#### **REMARKS**

#### **OATH/DECLARATION DEFECTIVE**

FIG. 16

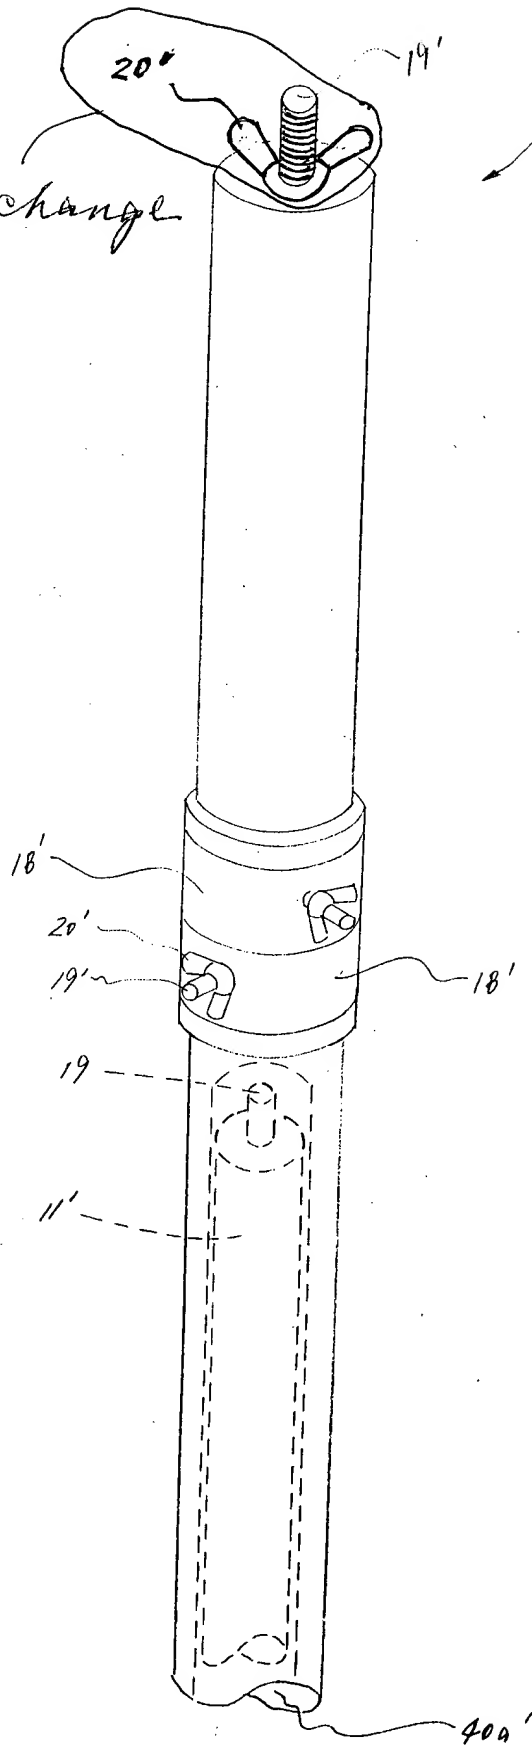
The following reference signs are not included in the drawings: "16' " as discussed on page 18 line 1; "20' " on top of pole 40' as discussed on page 18 first paragraph. Correction is required.

Accordingly, Applicant has amended the specification to conform the reference signs mentioned therein to be drawings. Further, Applicant is submitting herewith proposed drawing corrections to conform the drawings to the specification.

Proposed  
drawing change
